AMENDMENTS TO THE DRAWINGS

REMARKS

Fig. 1
PRIOR ART

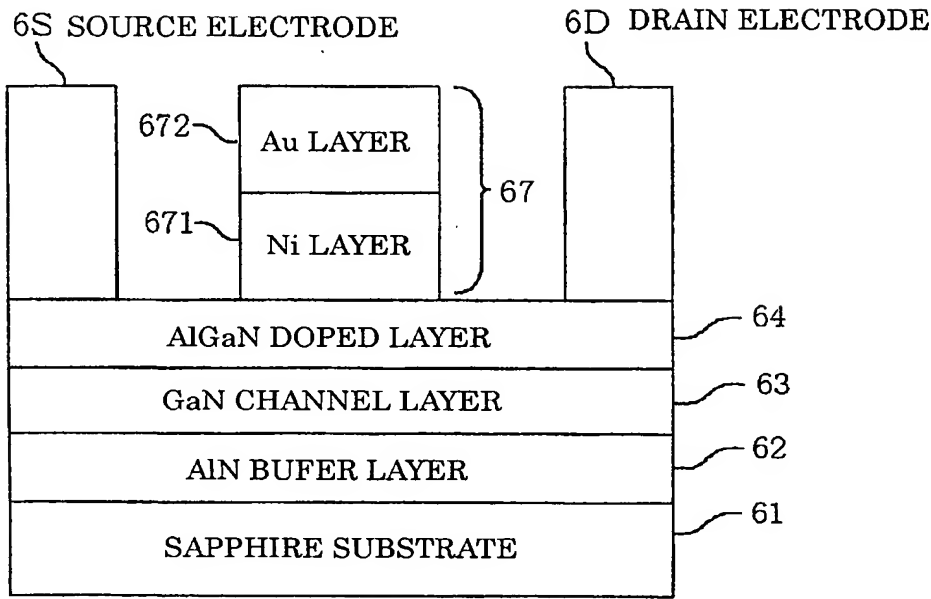
The drawings were objected to and the requirement was made to label Figures 1-4 as prior art. As shown above, new Figures 1-4 are submitted herewith to include the designation "Prior Art." The drawings were also objected to for not showing the first metal layer comprising NiN or PdN. In response, a new figure, Figure 8A, is added, together with appropriate additional text in the specification, to show this feature. No new matter has been added.

Please replace the formal drawing sheets currently on file with the replacement drawings sheets submitted herewith. The changes to the drawings are to label Figs. 1-4 as Prior Art and to add new Fig. 8 to show a feature required by the Examiner. No new matter is being added.
